Mandatory Product Update/Safety Bulletin

PCWU 15-012 Rev B (Replaces PCWU 15-012)
 PC3/Titan Overspeed Safety Device - Safety Bulletin
 October 20, 2015

SUB COMPONENT
Overspeed Safety Device - Flywheel Assembly

FIG D1 - Pass

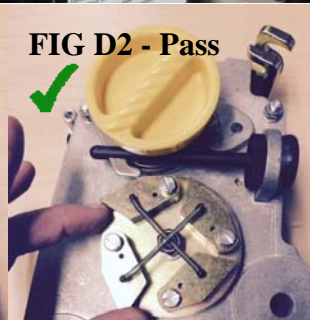
1. Prior to performing Daily Inspection Procedure checks, with Service Lift power off, remove Hoist Mainframe Cover (Fig C1) using a 4mm T-Handle. Locate the Flywheel Assembly (See Fig C2). **Manually rotate each flywheel counterweight (4 Total) on Flywheel Assembly** of the Overspeed Safety Device to ensure that their rotation past the outer diameter of the flywheel is limited as shown in Fig D1 & D2 below. If it can move too far and get caught on obstacles other than the trigger for the stop as shown in Fig E, the Flywheel does not pass inspection.

2. If Flywheel Assembly passes inspection, the Service Lift may be used as long as all other functions of the Daily Inspection Procedure have been completed. If Flywheel Assembly does not pass inspection, Service Lift must be removed from service until update has been applied.
3. Until update below has been installed, repeat steps 1-2 above prior to each daily use.
